REMARKS

Claims 2, 6, 12-15 have been canceled, and claims 16-20 have been newly added by amendment. Claims 1, 3-5, 7-11, 16-20 are currently pending in the application.

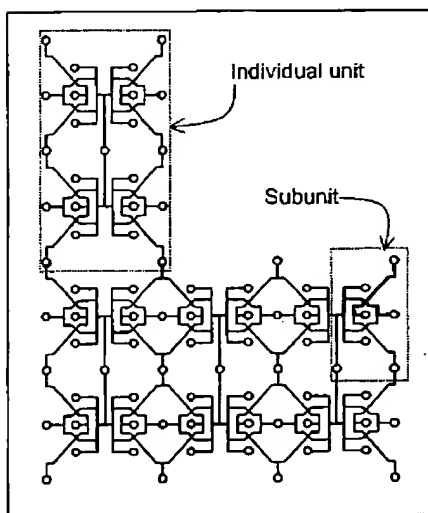
The following illustrations also serve to highlight the symmetry and structure of the

microfluidic systems that are the central point of the invention. Each grouping illustrates an individual unit, wherein the central black circle represents the central supply reservoir, and the blue ellipses or circles represent microfluidic channel and components. Fluidic connections between the central reservoir and the peripheral units are not shown for the sake of

clarity. The ellipses are arranged in a four-fold symmetric fashion, and each represents a subunit as defined by the invention. The blue circles represent a single assay unit, and each is related by an eight-fold symmetry. The dotted lines indicate mirror planes, that superimpose one element (ellipse or circle) onto another as by reflection. The fact that the microfluidic components are related by symmetry means that fluidic pathways are equidistant, transit times for reagents or

substrates introduced into the microfluidic system are similar, equal applied voltages generate equivalent field strengths, detection points lie at fixed, periodic intervals within each individual unit and by extension, from unit to unit in devices that are composed of multiple individual units. This symmetry and structure is found in all the Figures 1-3.
